CR-Formv3	
CHANGE REQUEST	
✎ 25.926 CR xxx ✎ rev - ✎ Current version: 3.2.0 ✎

Title:	✎ Correction on parameter "Maximum total number of transport blocks..."		
Source:	✎ Mitsubishi Electric (Trium-RD)		
Work item code:	✎ Release 99 issues	Date:	✎ 23 rd November 2000
Category:	✎ F	Release:	✎ R99
	Use <u>one</u> of the following categories: F (essential correction) A (corresponds to a correction in an earlier release) B (Addition of feature), C (Functional modification of feature) D (Editorial modification) Detailed explanations of the above categories can be found in 3GPP TR 21.900.		Use <u>one</u> of the following releases: 2 (GSM Phase 2) R96 (Release 1996) R97 (Release 1997) R98 (Release 1998) R99 (Release 1999) REL-4 (Release 4) REL-5 (Release 5)

Figure 4.1: UE transport channel processing limitations in uplink

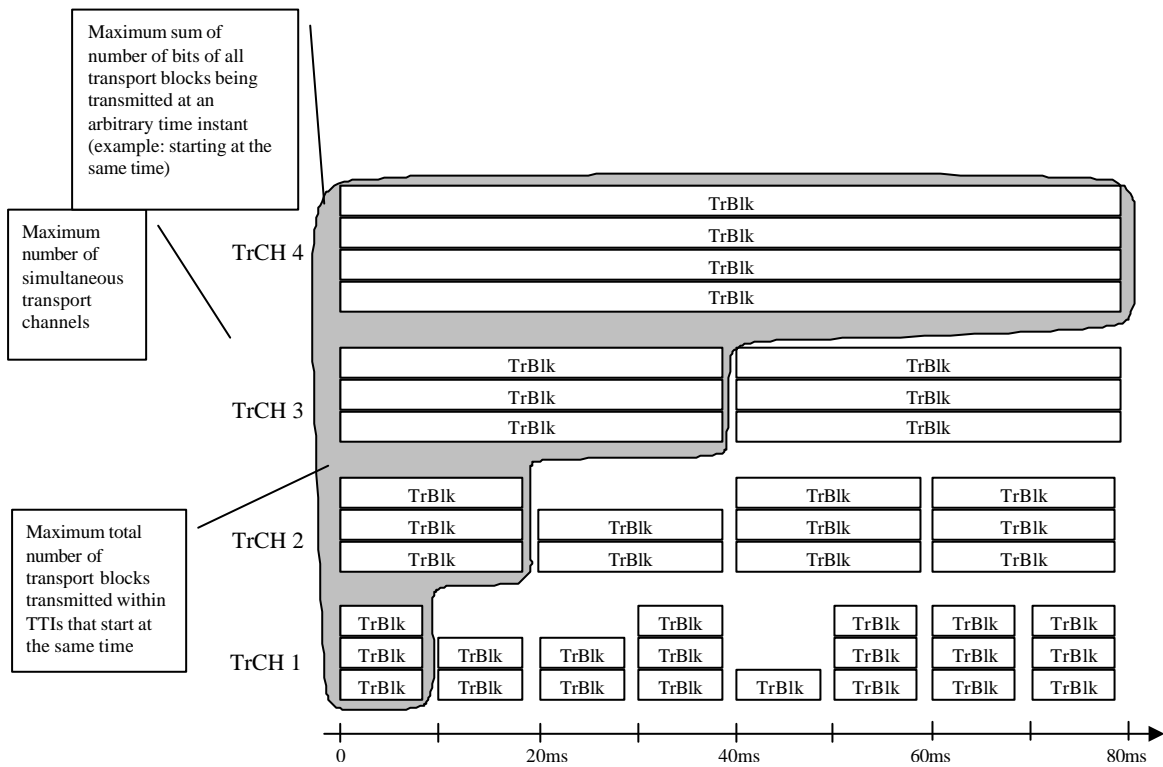
Clauses affected:	✎ 4.5.1, 4.5.2.		
Other specs affected:	<input type="checkbox"/> Other core specifications <input type="checkbox"/> Test specifications <input type="checkbox"/> O&M Specifications	✎	
Other comments:	✎ There were revision marks in figure 4.1. in the original document. These revision marks were forgotten to be accepted. We have accepted them when editing the CR to avoid confusion.
